Bi-directional TCLKB proposal

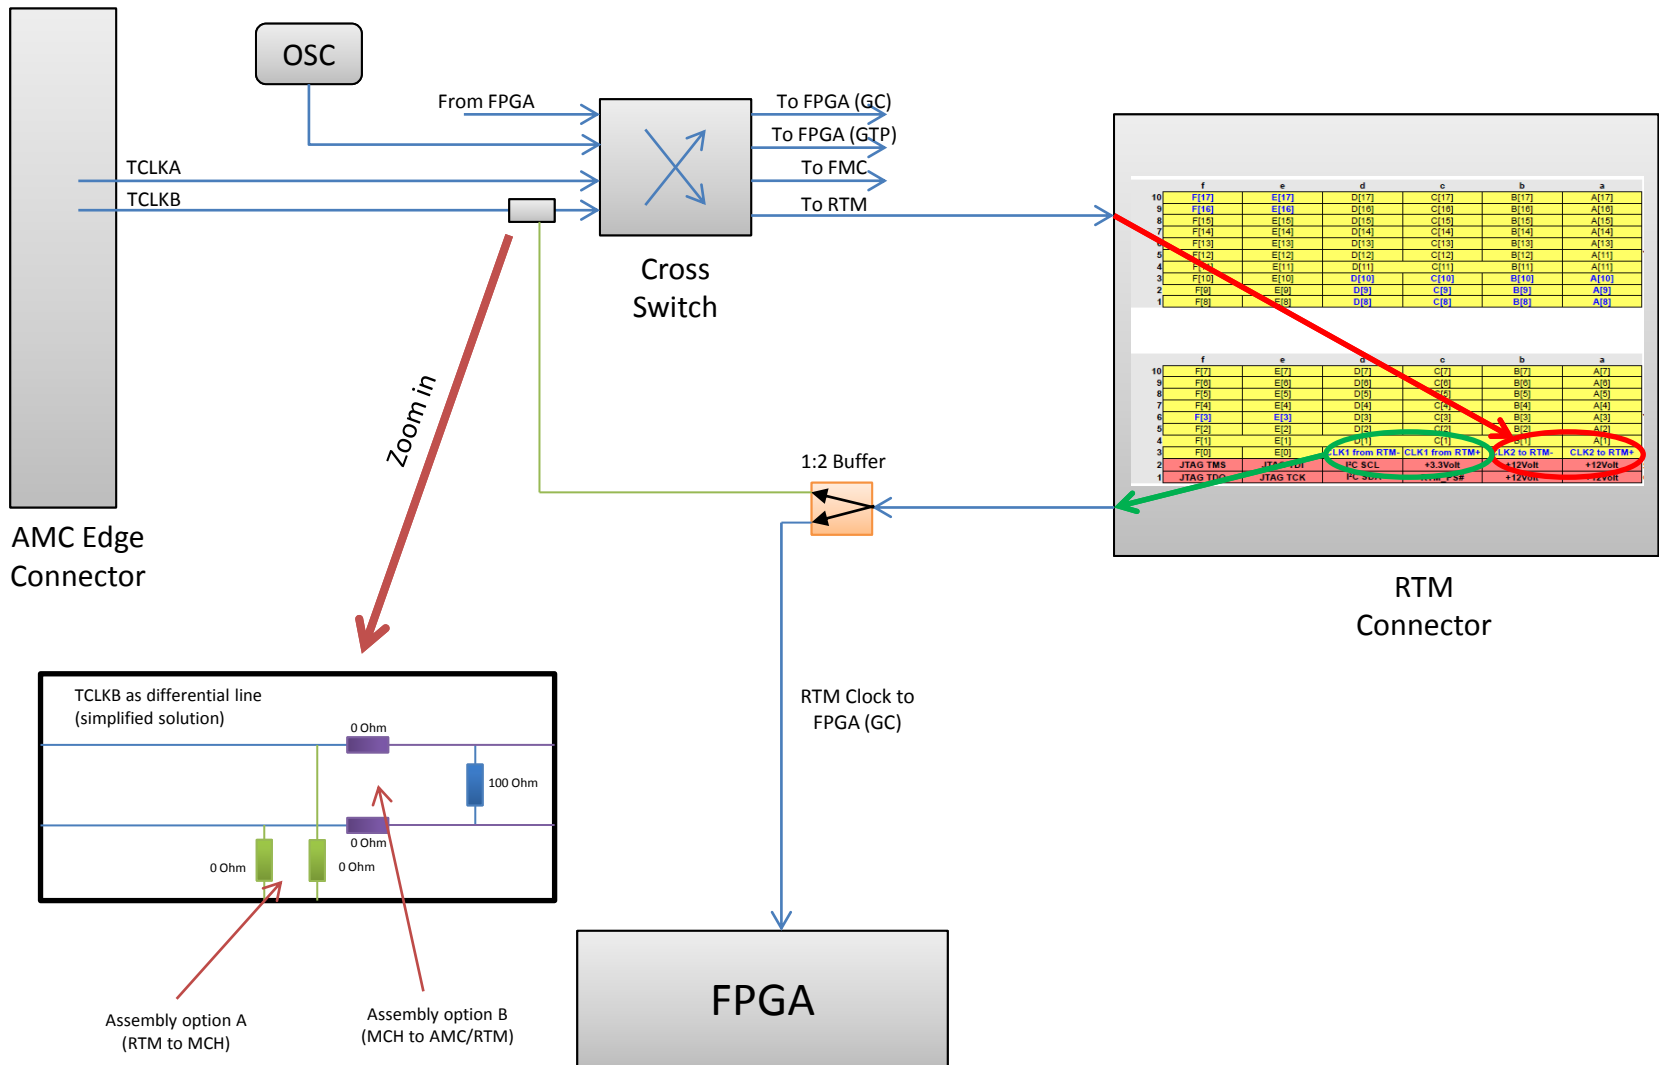
- Only one pair of 0 Ohm resistor should be assembled
- 1:2 Buffer should really separate the two outputs
 - No reflections or short circuits should be seen on the other output
